# Amendment Notice 3

**Licence Number** L4496/1988/11

**Licence Holder** Big Bell Gold Operations Pty Ltd

**Premises** Blue Bird Gold Mine  
Mining Tenements; G51/9, L20/75, L51/18, L51/78, M20/12, M20/45, M20/68, M20/70, M20/71, M20/73, M20/77,, M20/107, M20/214, M20/219, M20/249, M20/421, M51/6, M51/12, M51/31, M51/33, M51/35, M51/39, M51/62, M51/75, M51/92, M51/96, M51/132, M51/190, M51/199, M51/200, M51/203, M51/209; M51/211, M51/233, M51/236, M51/237, M51/254, M51/321, M51/393, M51/437, M51/438, M51/439, M51/440, M51/455 M51/459, M51/462, M51/463, M51/483, M51/485, M51/486, M51/491, M51/492, M51/493, M51/494, M51/495, M51/523, M51/539, M51/569, M51/572, M51/581, M51/564, M51/666, M51/671, M51/672, M51/757, M51/762, M51/781; M51/784, M51/788, M51/793, M51/794, M51/795, M51/800, M51/801, M51/820, M51/824, M51/834; E51/1484  
MEEKATHARRA WA 6642

9. The Licence is amended by removing the map in schedule 1 Map of Premises and insertion of the map below;

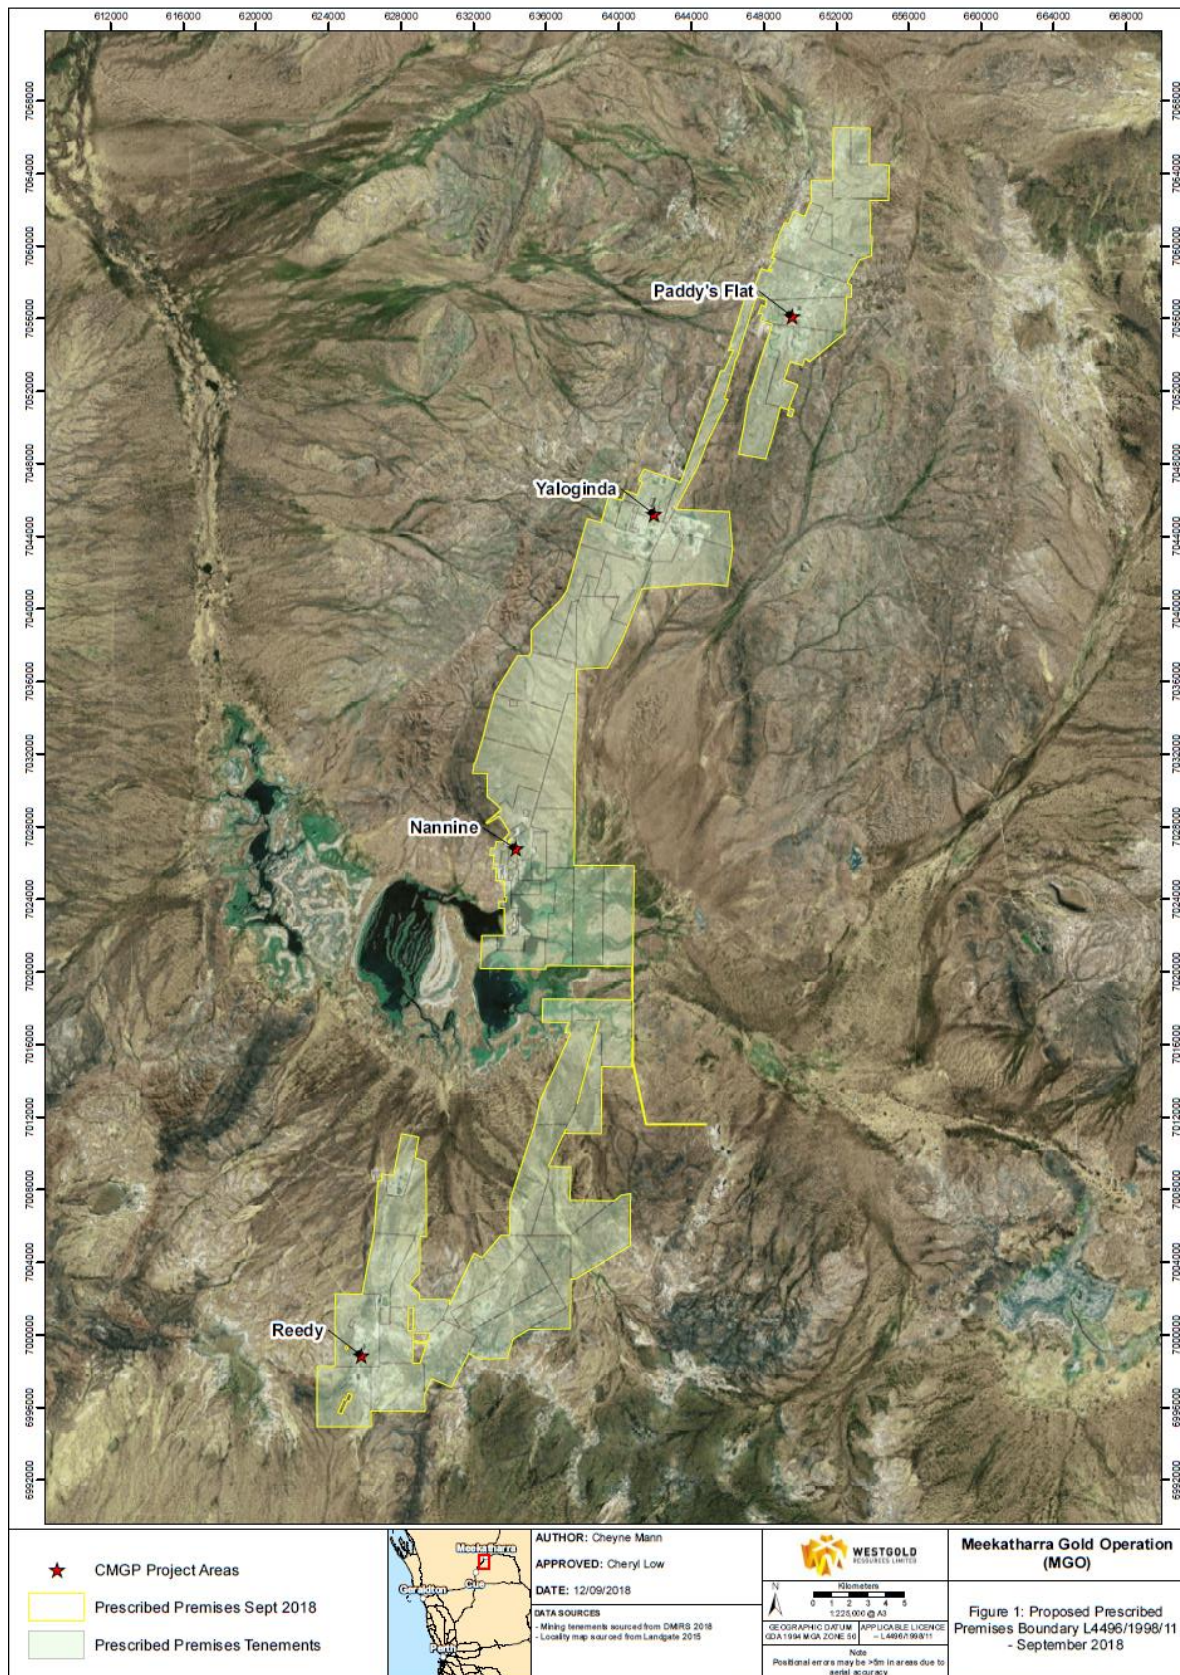
8. The Licence is amended by removing the map in Schedule 1 Map of tyre disposal locations and insertion of the maps below;

Schedule 1 tyre burial location map has been replaced with four maps outlining the location of the new tyre burial locations.
